Turbocharger Smart Remote Actuator (SRA) Faults

M-255-016

(March 2009)

All CXU,CHU,GU,TD,MRU,LEU models built with MP7, MP8, MP10

SRA Bulkhead Connector with Back Shell

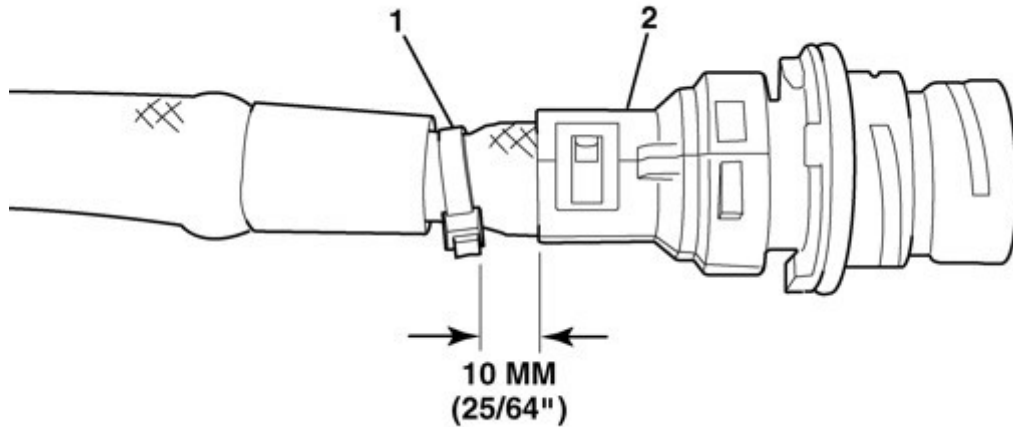
Wires within the smart remote actuator (SRA) connector located on the right-hand side of the engine below the turbocharger, are subject to vibration during engine operation. This vibration can result in terminal fretting which produces very fine dust particles, and can be seen as a fine green dust inside the connector. When these particles migrate between the female and male pin connections, intermittent contact problems will result and be made evident by SID 27 and PSID 232 fault codes.

Installing a connector back shell (part number 3985620) on the back of the male (mounting bracket side) SRA connector and securing the harness wires by installing a tie wrap around the fabric cover as shown in the illustration below, will correct this condition by dampening the vibration to reduce terminal fretting.

1. Disconnect the SRA connector (the bottom connector on the mounting bracket), and then unscrew the bulkhead nut to remove the connector body from the mounting bracket.
2. Clean both the SRA side and engine harness side of the connector with a high-quality electrical contact cleaner.
3. Install the plastic back shell (part number 3985620) over the back of the connector (male side), making sure the fabric cover extends inside the shell as shown in above.
4. Secure the wires by installing a tie wrap (part number 948211) around the fabric cover immediately behind the plastic back shell (within 10 mm [25/64"] of the rear of the shell).
5. Reinstall the connector body to the mounting bracket, and then reconnect the connector. Road test the vehicle and recheck the system for faults.
